# ADDENDUM

## EIA Espejo de Tarapacá

### Region of Tarapacá Chile

To do so, searched answer fully the observations, requirements and questions to the project, following the same order contained in the consolidated report of clarifications, corrections and/or additions (ICSARA) N ° 1.

**Figure 1-1: Operation of the project outline.**

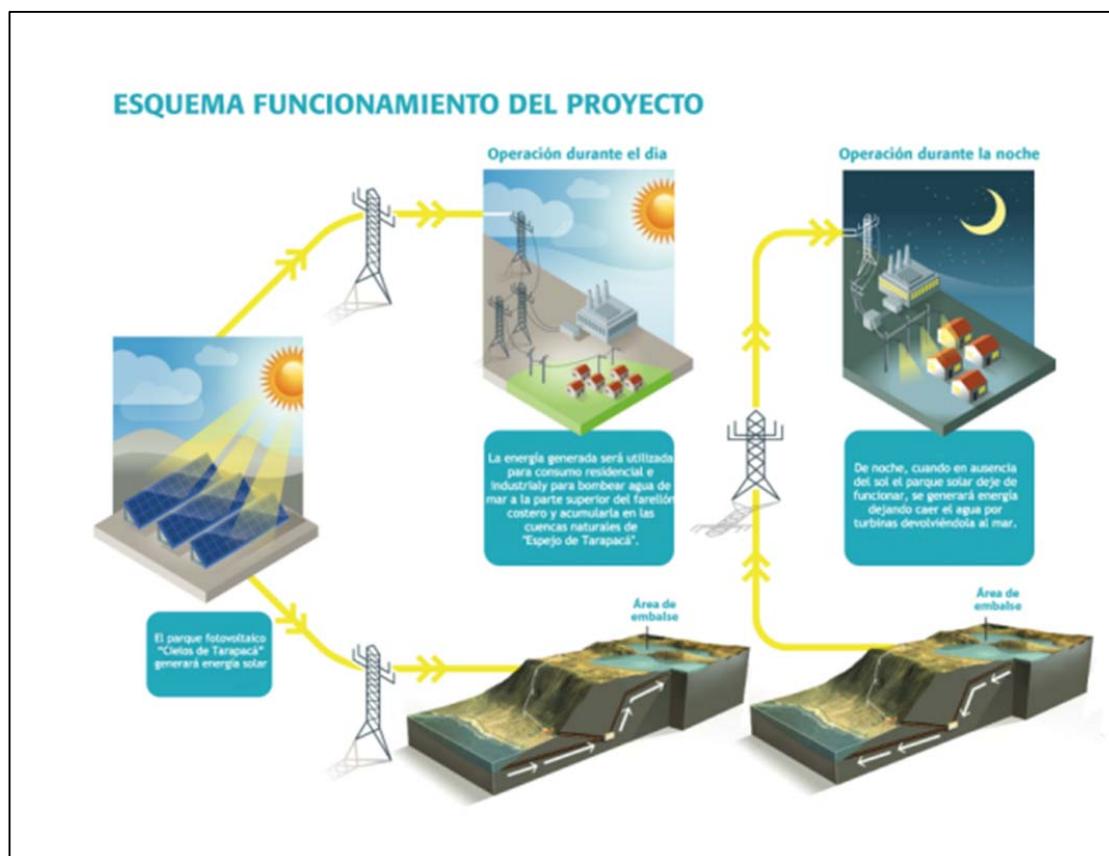
**1.2. With regard to the generation of power, the holder must clarify the fact that the EIA reported that the plant will consume 2.28 GWhday, annual average, up sea water to the plateau, to produce 1.75 GWhday, annual average.**

The relationship between the project's central pumping with seawater, Espejo de Tarapacá and the photovoltaic Park, shown in the following figure:

1. During the pumping phase, of a **100%** the energy consumed by the plant, about 11.62% will be lost in the use of the pump and motor, while the **88.38%** remaining will be stored in the reservoir to be used in power generation.
2. Then during the phase of generation, this **88.38%** shall be used throughout the work. Thus, in general terms a **76,76%** power will be effectively generated by the Central.

**Figure 7-8: Carbon organic Total [mg/l] for reservoir (North West).**

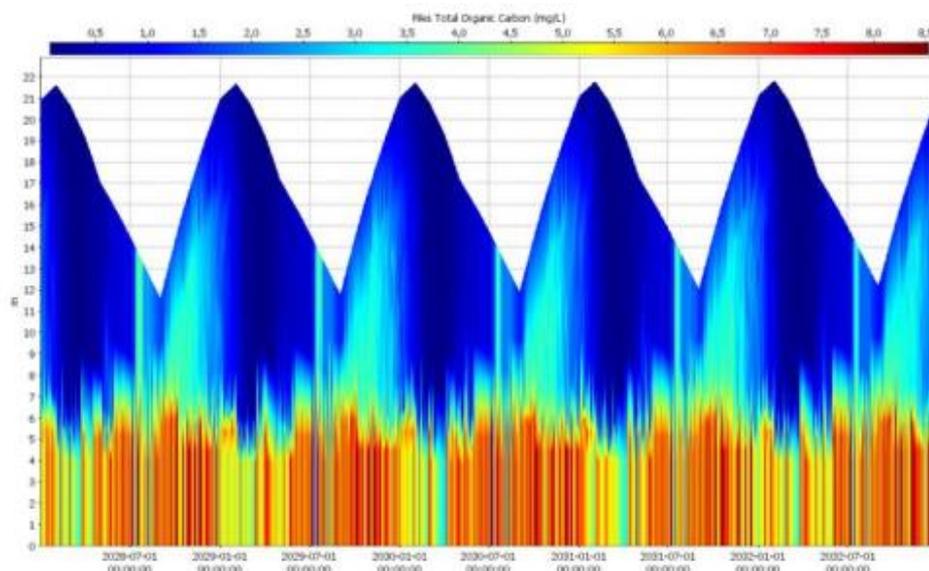
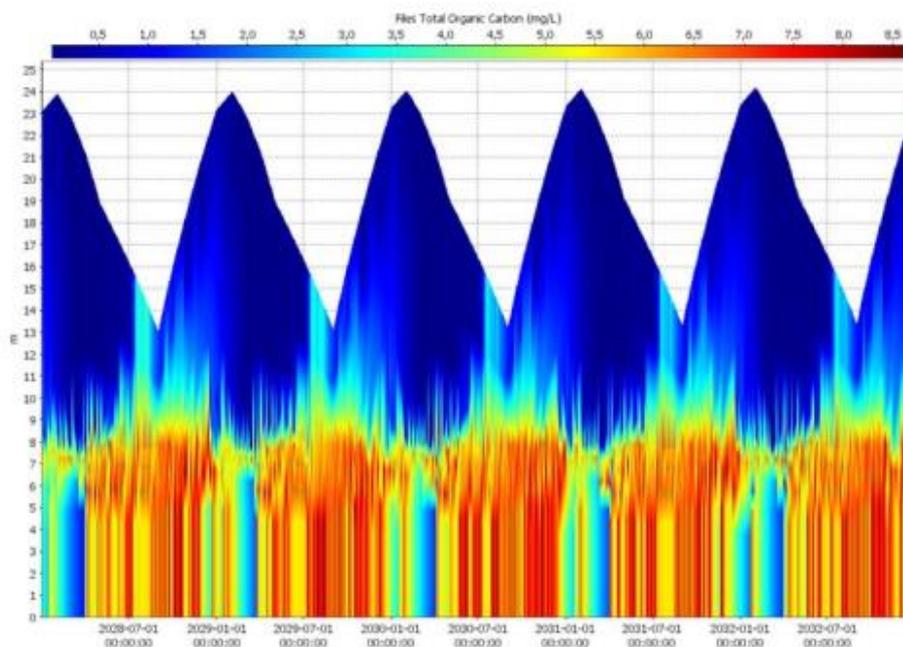
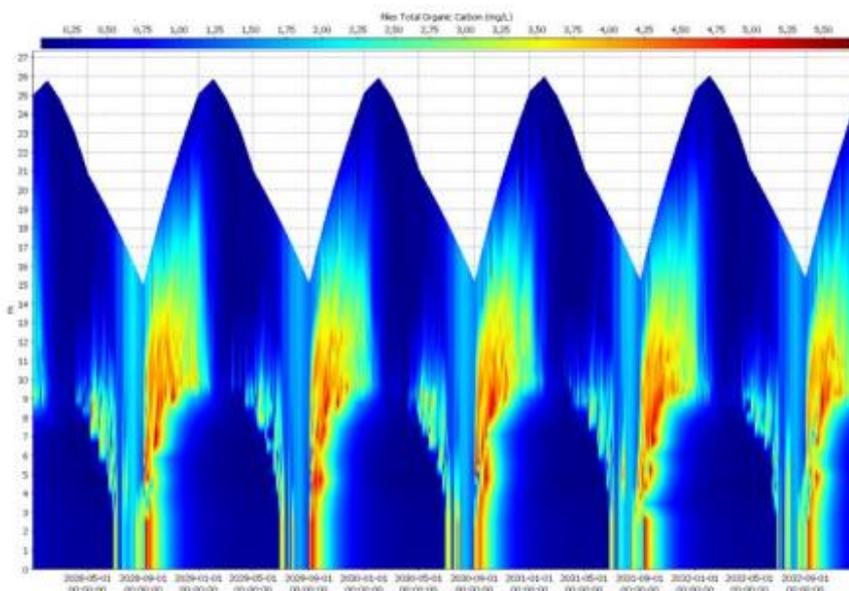
**7-8.4 according to figure 3.2. "Behavior of the level or dimension of filling for the reservoir over a year system" (report Eridanus), seen that the greater amount of water will be accumulated during the summer or warm, descending colder, behavior that is similar to that described for the index during the months of Upwelling Coastal and biomass Zooplankton during a year in waters off northern chile (R. Fuenzalida, 1992). Also, this behavior is consistent to a certain extent with that reported by the holder for the parameters of turbidity (table V, Figure 12) and M.O.T (table V, Figure 13), in the section 3 "Chemical Oceanography" (annex 3.2. Line Base marine environment), where higher concentrations of these parameters are indicated in Spring 2013 and 2014 summer. In this regard, it stated the following:**

On the other hand, the organic matter is represented by the organic carbon in the modeling. Results of this showed that higher values were below 8.5 mg/L for a simulated long-term horizon. At elevations greater than 8 m concentrations in the reservoir does not exceed 3.5 mg/l in terms of mixing, and the greater part of the year levels are around 1 mg/L. (see Figure 7-8).

**Figure 7-17. Figure 50 corrected Annex 4.3 of the EIA. Report Stepswater.**

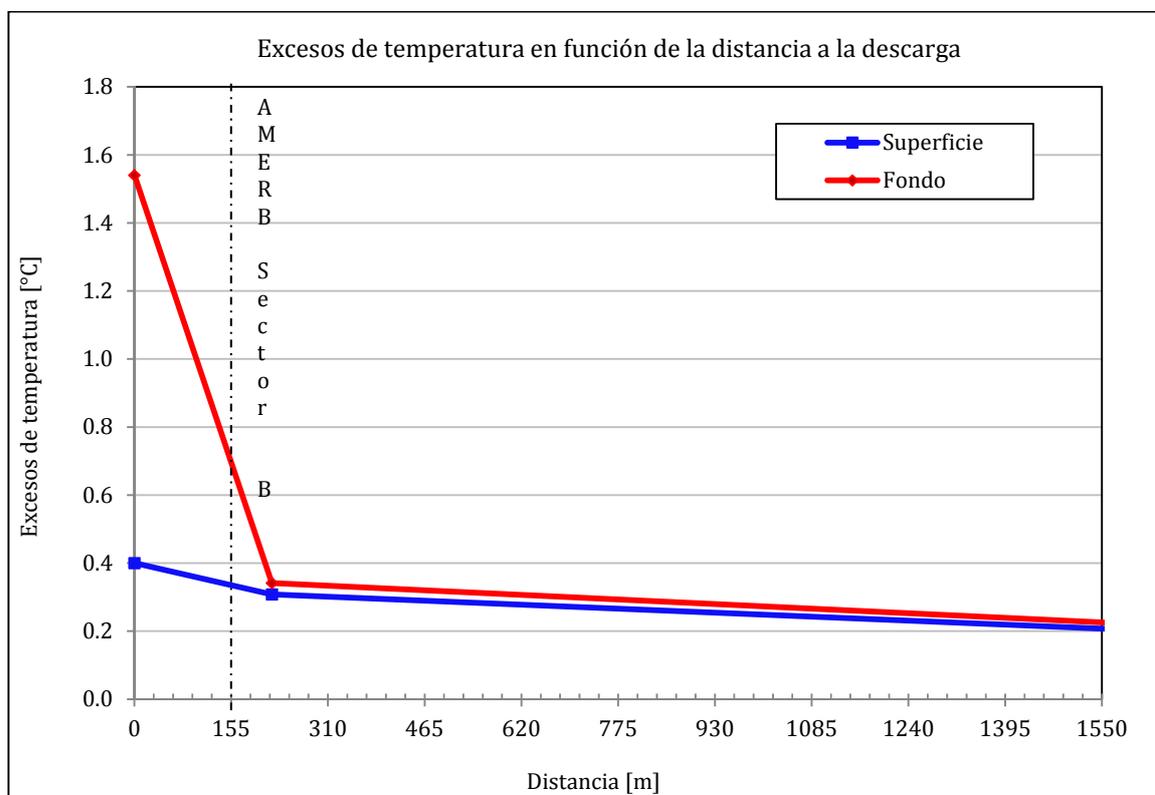
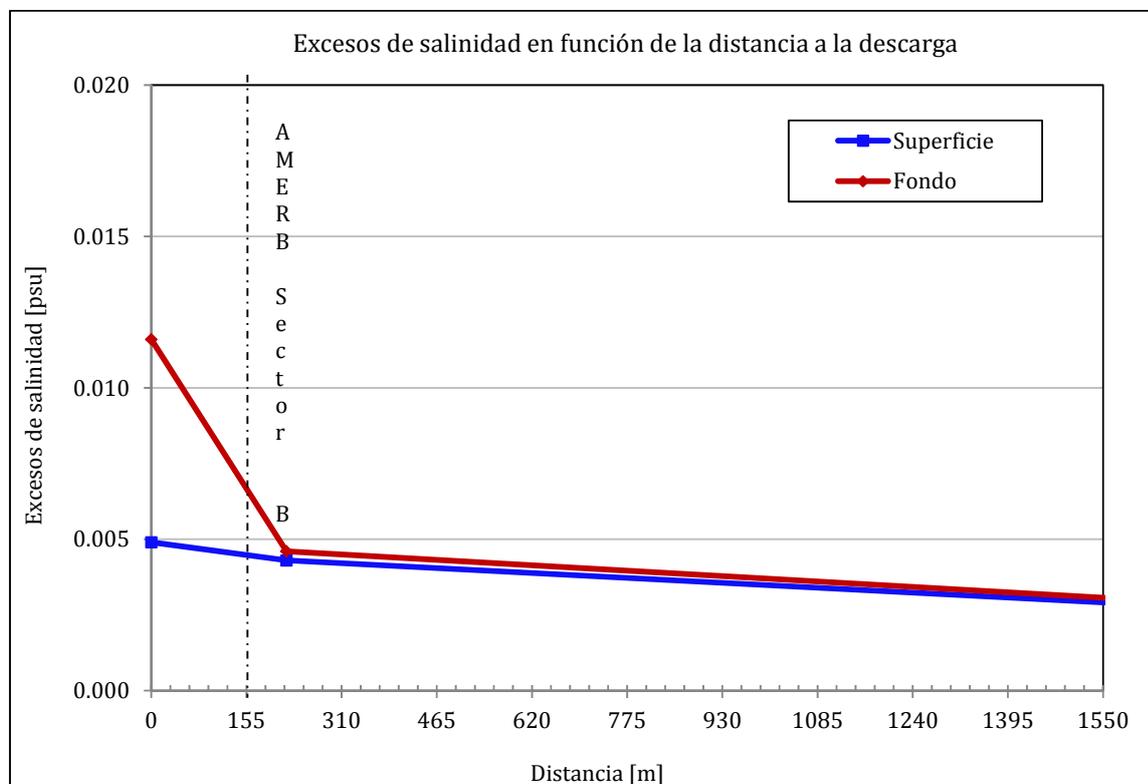
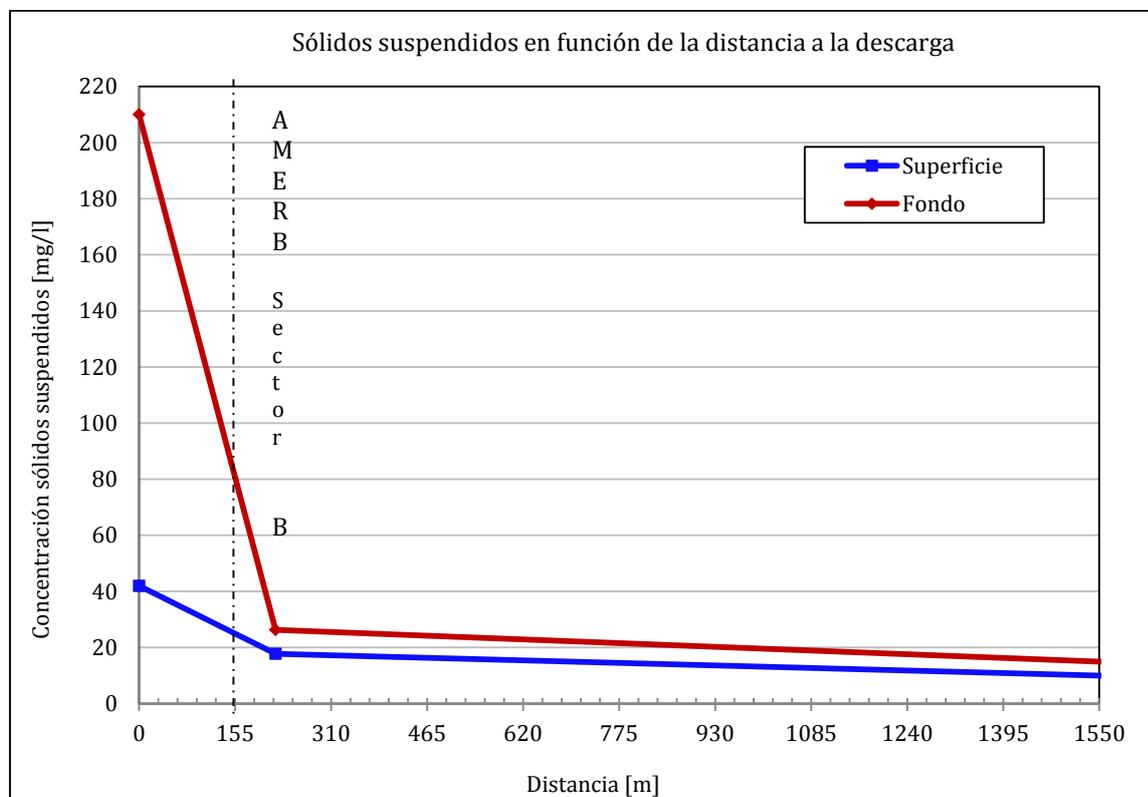
- **Clarify why the holder located in the line of location of the AMERB Sector B at a distance of 250 m depending on the distance from the source of discharge, figure the 50, 51 and 52 every time this would be located at a minimum distance of 155 m from the point of discharge. Concerning the holder must revalue such conclusions, correcting the position and considering all the scenarios outlined above.**

noteworthy that in figures 7-14; 7-15 and 7-16 of this addendum is the correction of the 50 figures; 51 and 52 referred to in question and indicating the distance from the AMERB curves away from the excesses with regard to the discharge point.
